Access Compliance Report

Public Rights-of-Way

Intersection ID: N/A	Main Street: INDEPENDENCE_RD	Cross Street: BUICK_DR	Location: NE
ADA ID: AAE9902B0F68	Ramp Type: PerpDiag	Initial Pass/Fail: Fail	Overall Compliance: No
		Severity Score: 12.5

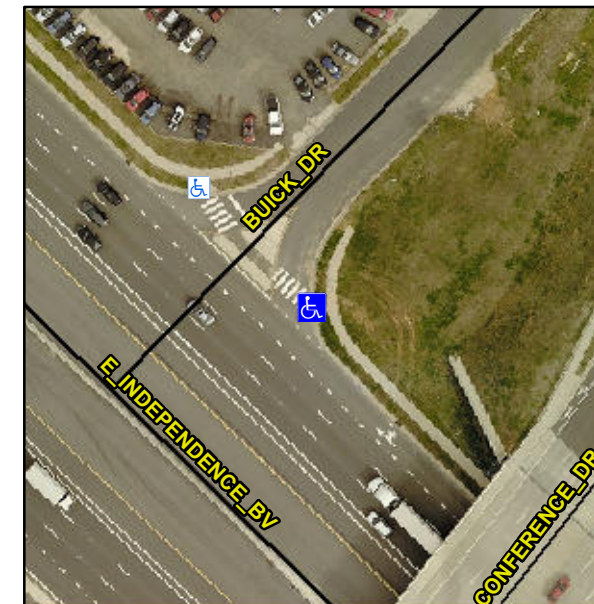
Not Found, R304.2.2

Compliance	Description	Data	Compliance	Description	Data
N/A	Ramp Length (in)	71.0	No	Ramp Slope (%)	9.2
Yes	Ramp Width (in)	48.0	Yes	Ramp XSlope (%)	0.2
N/A	Flare Type LT	N/A	N/A	Flare Type RT	N/A
N/A	Flare Slope LT (%)	N/A	N/A	Flare Slope RT (%)	N/A
N/A	Flare Traversable LT?	N/A	N/A	Flare Traversable RT?	N/A
N/A	Landing Length (in)	N/A	N/A	DWS Provided?	N/A
N/A	Landing Width (in)	N/A	N/A	DWS Contrast?	N/A
N/A	Landing Slope (%)	N/A	N/A	DWS Length (in)	N/A
N/A	Landing X Slope (%)	N/A	N/A	DWS Full Width?	N/A
N/A	Landing Curb? (Y/N)	N/A	N/A	DWS Offset (in)	N/A
N/A	Shared Landing?	N/A			
N/A	Gutter Ponding?	N/A	N/A	Gutter Slope (%)	N/A
N/A	Gutter Lip Ht (in)	N/A	N/A	Gutter X Slope (%)	N/A
N/A	Painted X Walk1?	Yes	N/A	Painted X Walk2?	No
	X Walk 1 Direction	To NW		X Walk 2 Direction	To SW
N/A	X Walk 1 Width (in)	119.0	N/A	X Walk 2 Width (in)	N/A
	X Walk 1 Slope (%)	4.9		X Walk 2 Slope (%)	3.0
	X Walk 1 X Slope (%)	3.1		X Walk 2 X Slope (%)	3.8

Remove & Replace Curb Ramp With Two New Directional Ramps or Equivalent.
